UNITED STATES PATENT AND TRADEMARK OFFICE

APPLICATION NO.	FILING DATE	FIRST NAMED INVENTOR	ATTORNEY DOCKET NO.	CONFIRMATION NO.
10/750,658	12/31/2003	Ki Hyup Kim	11037-175-999	1614

Office Action Summary

DETAILED ACTION***Claim Rejections - 35 USC § 102***

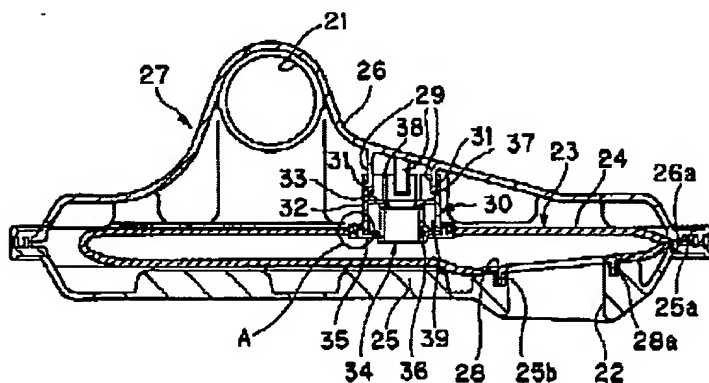
2. Claims 1-3 and 6-7 rejected under 35 U.S.C. 102(a) as being anticipated by the Japanese Reference JP2002-186807, hereinafter '807. '807 teaches an oil filter comprising a nonwoven

[0028] fabric filter 23 in the hollow space defined between upper and lower covers, each having a respective opening 21,22 for the flow of oil therethrough. A valve body (30,32,35) is integral with the

top cover [as in claims 1, 3 and 6] and includes a “gasket” (protrusion 31 fitting in recess 37) integral therewith [as in claims 2 and 6]. One of the covers can include a multitude of holes (see e.g. the top cover of figure 4 and the bottom cover of figure 6) [as in claims 2 and 7]. During the filtering process, oil entering opening 22 and flowing to the space enclosed by the filter 23 (specifically, oil flowing into the left side portion of the enclosed space in the figure above)

necessarily flows "from the valve body and into the hollow portion" existing downstream of the filter 23 after being filtered.
